## Grandview Reserve Master Development Drainage Plan

July 2020

**Engineering Review**

SKP-20-001

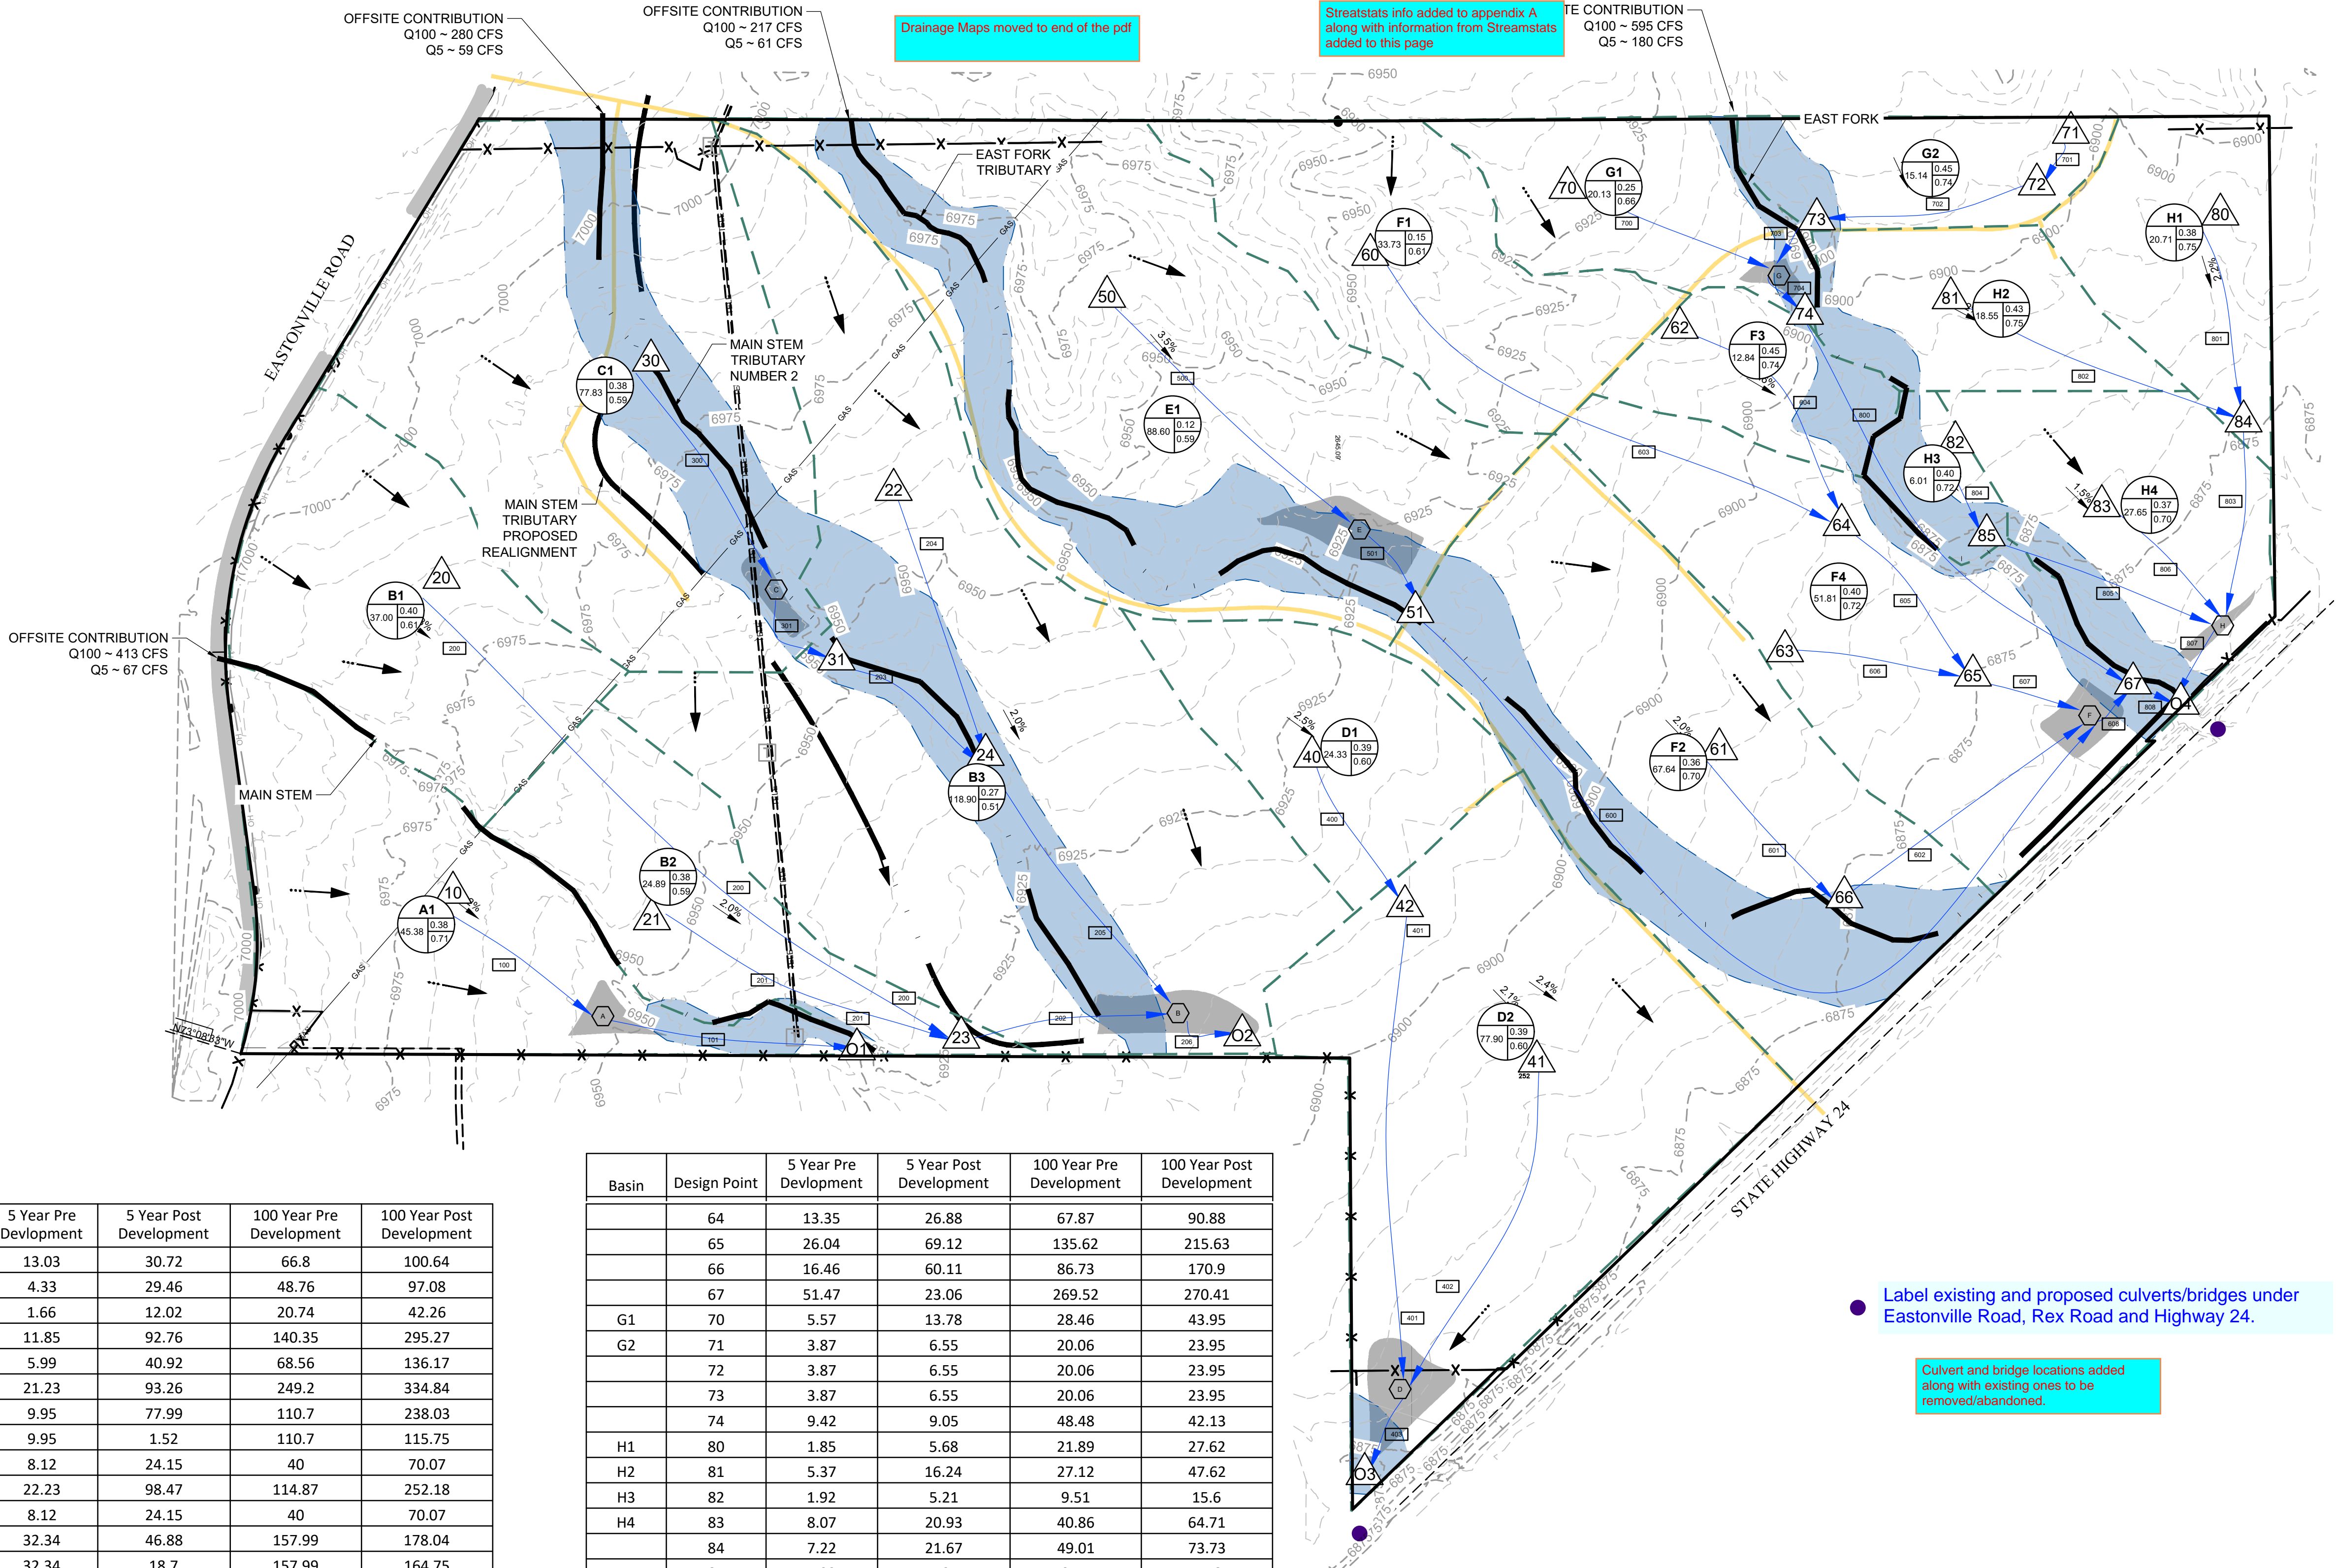
Please move pdf sheets 22-33 (drainage plans) to the end of the pdf.

Label the entire contributing basins including acreage and CN values. Provide a separate exhibit if necessary.

Drainage Maps moved to end of the pdf

Streamstats info added to appendix A along with information from Streamstats added to this page
